# Access Compliance Report

### (Curb Ramps)

Intersection ID: 53746	Main Street: SPRINGWOOD_ESTATE_DR	Cross Street: CANTERBURY_CASTLE_DR	Location: NW
ADA ID: 8DDA74FE30F3	Ramp Type: Perp	Initial Pass/Fail: Fail	Overall Compliance: No
		Severity Score: 25

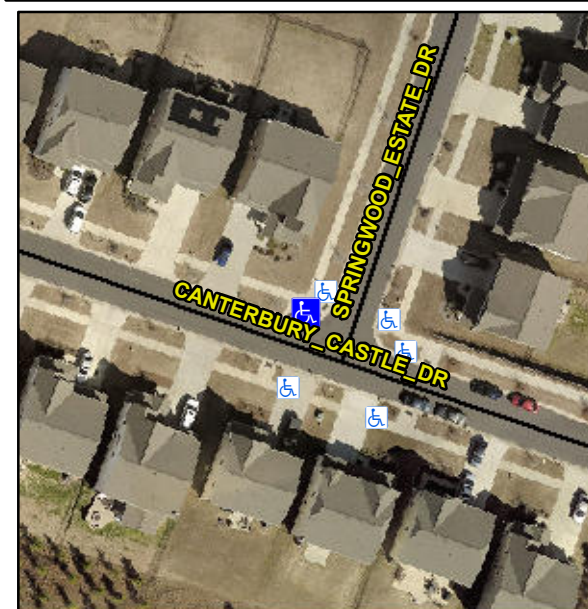
**R304.5.3**

Compliance	Description	Data	Compliance	Description	Data
N/A	Ramp Length (in)	96.0	Yes	Ramp Slope (%)	6.2
Yes	Ramp Width (in)	48.0	No	Ramp XSlope (%)	8.1
N/A	Flare Type LT	N/A	N/A	Flare Type RT	N/A
N/A	Flare Slope LT (%)	N/A	N/A	Flare Slope RT (%)	N/A
N/A	Flare Traversable LT?	N/A	N/A	Flare Traversable RT?	N/A
N/A	Landing Length (in)	N/A	N/A	DWS Provided?	N/A
N/A	Landing Width (in)	N/A	N/A	DWS Contrast?	N/A
N/A	Landing Slope (%)	N/A	N/A	DWS Length (in)	N/A
N/A	Landing X Slope (%)	N/A	N/A	DWS Full Width?	N/A
N/A	Landing Curb? (Y/N)	N/A	N/A	DWS Offset (in)	N/A
N/A	Shared Landing?	N/A			
N/A	Gutter Ponding?	N/A	N/A	Gutter Slope (%)	N/A
N/A	Gutter Lip Ht (in)	N/A	N/A	Gutter X Slope (%)	N/A
N/A	Painted X Walk1?	No	N/A	Painted X Walk2?	N/A
	X Walk 1 Direction	To SW		X Walk 2 Direction	N/A
N/A	X Walk 1 Width (in)	N/A	N/A	X Walk 2 Width (in)	N/A
	X Walk 1 Slope (%)	3.6		X Walk 2 Slope (%)	N/A
	X Walk 1 X Slope (%)	4.3		X Walk 2 X Slope (%)	N/A

**Remove & Replace Entire Ramp.**
